NPF-10/15-275

ATTACHMENT C
SONGS UNIT 2
PROPOSED TECHNICAL SPECIFICATIONS

ATTACHMENT H
SONGS UNITS 2 AND 3
PLANT PROTECTION SYSTEM SETPOINT EVALUATION

Figure H-1

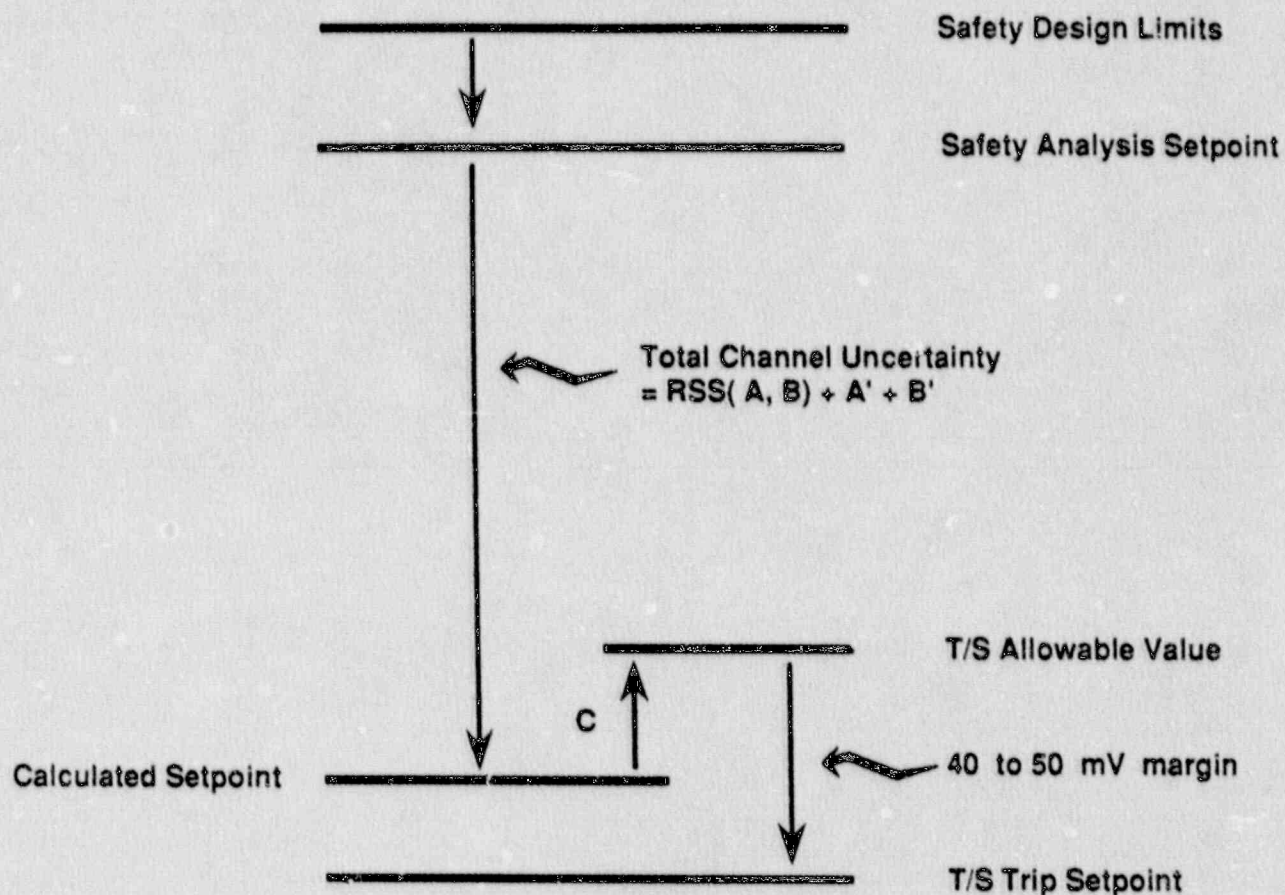
The C-E methodology for instrument setpoint calculations is consistent with ANSI/ISA-67.04-1988 "Setpoints for Nuclear Safety Related Instrumentation in Nuclear Power Plants", and includes the following basic components:

Figure J-5

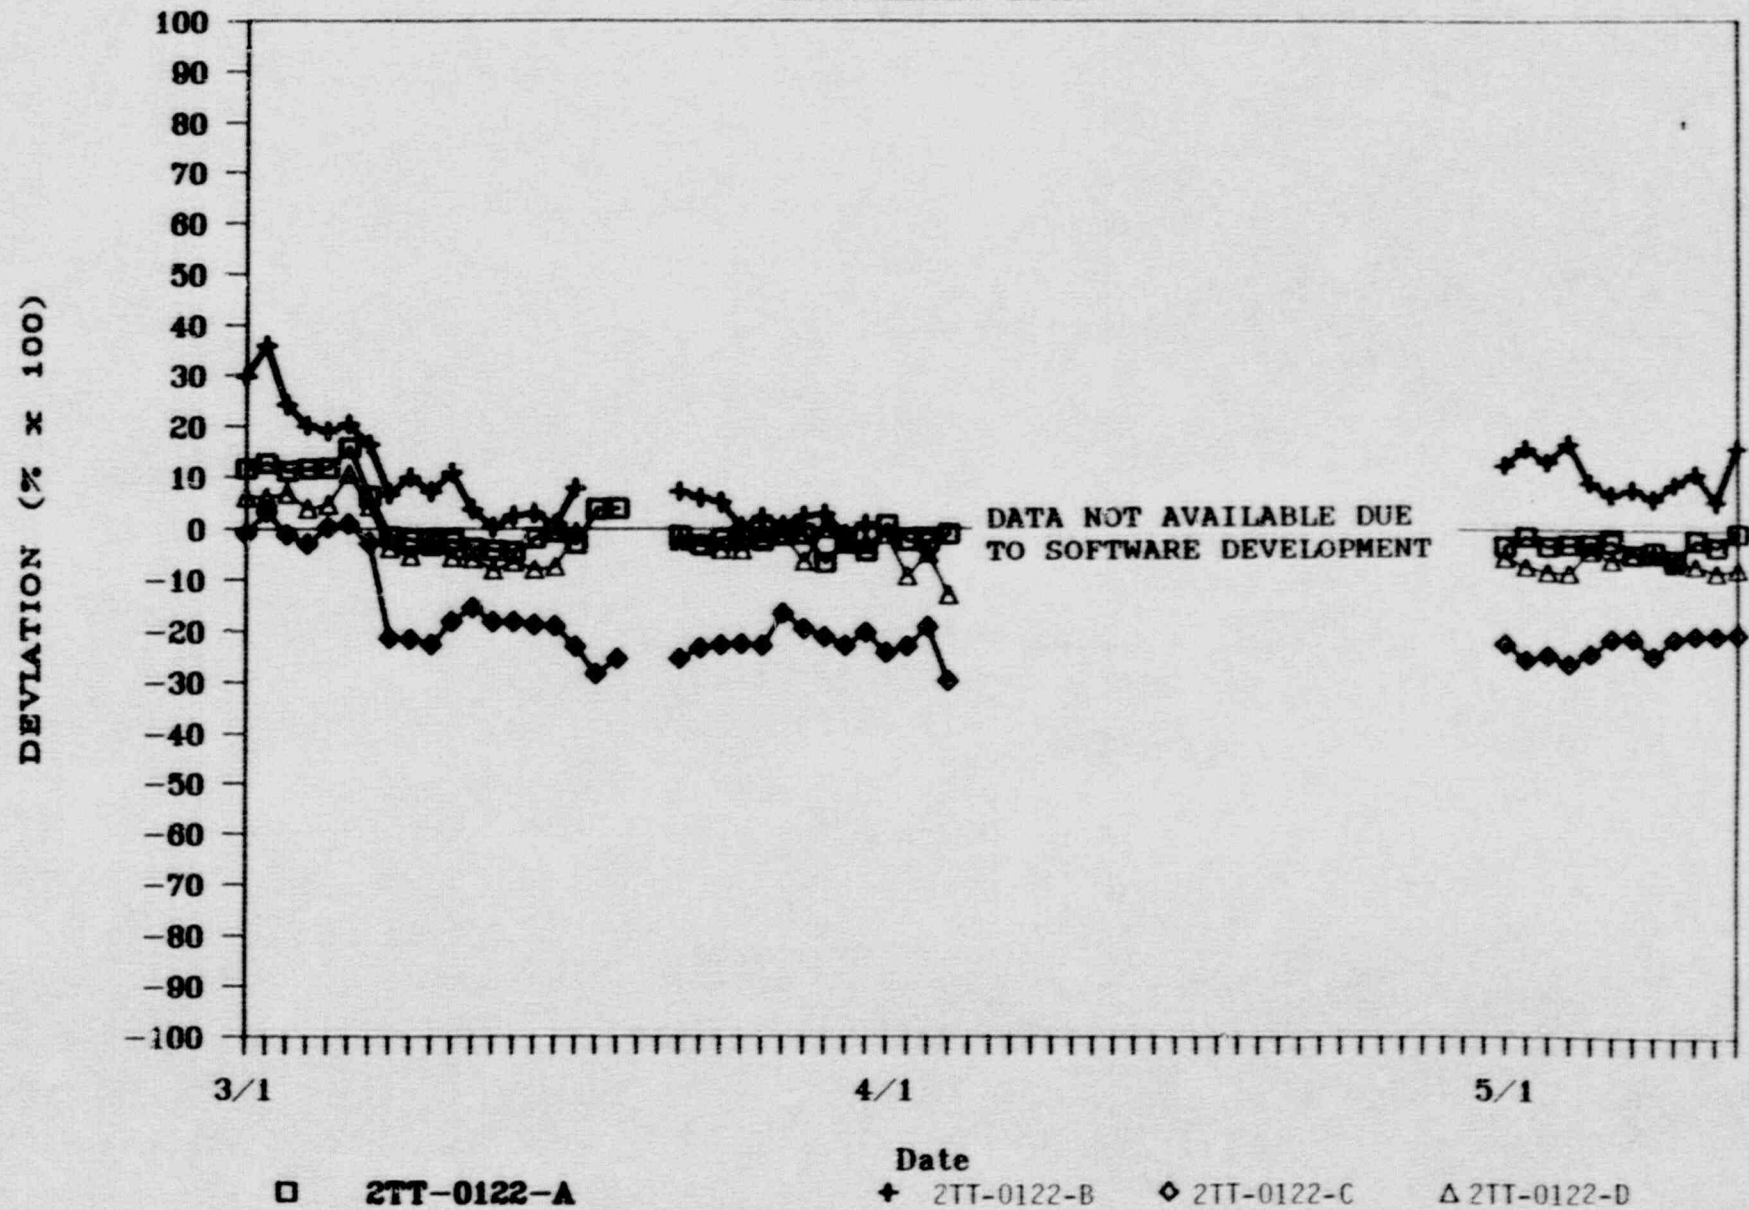
An example of a case where RIMS provided early indication of a transmitter abnormality occurred in December, 1988 for Unit 2 steam generator level transmitter, 2LT-1113-4. RIMS output (Figure 5 attached) indicated that the transmitter output was higher than the group average by approximately 0.5%. This agreed very well with the "as-found" data from the transmitter calibration performed the following month in January, 1989.
